FIELD CHANGE ORDER	NUMBER: DEBET-F003
--------------------	--------------------

APPLICABILITY: Rework "as needed" DEBET LAN BRIDGE 150 models, DEBET-AC, DEBET-AD, DEBET-RP, DEBET-RQ, DEBET-AU, DEBET-AG, DEBET-RU, DEBET-RG DEBET-AK and DEBET-RK at and below Revision Level "D01" for Customers experiencing problems as noted in the Problem/Symptom Section of this FCO document. This FCO implements ECO numbers 5417521-TWO015 and DEBET-TWO021.

SOLUTION: Replacement of ROM's located at locations E131 and E132 with those supplied in this FCO EQ Kit, number EQ-01646-01.

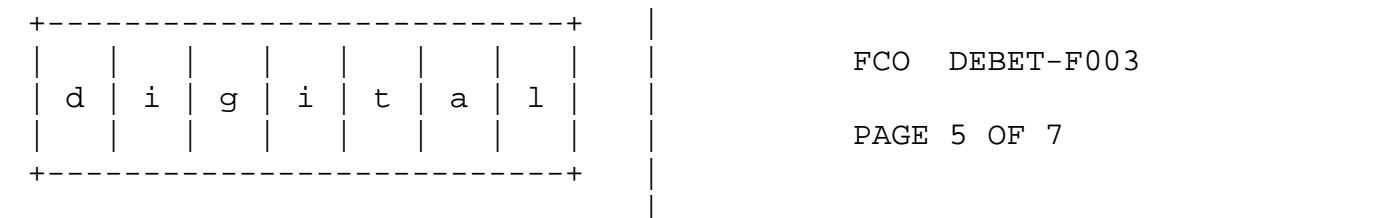
6. Remove three wire harnesses at J1, J4 and P1 of the Power Supply module, and the flat ribbon cable that goes thru the rear access hole of the plenum, located at the front center of the unit. (See Figure 2)

7. Remove the Fan Assembly Harness (70-22908-01) from the cable retainers located on the inner rear enclosure wall. (See Figure 2)
8. Loosen two captive screws on the plenum that the Power Supply board is attached to, and two Phillips head screws also located on the plenum at the front of the unit. (See Figure 2)
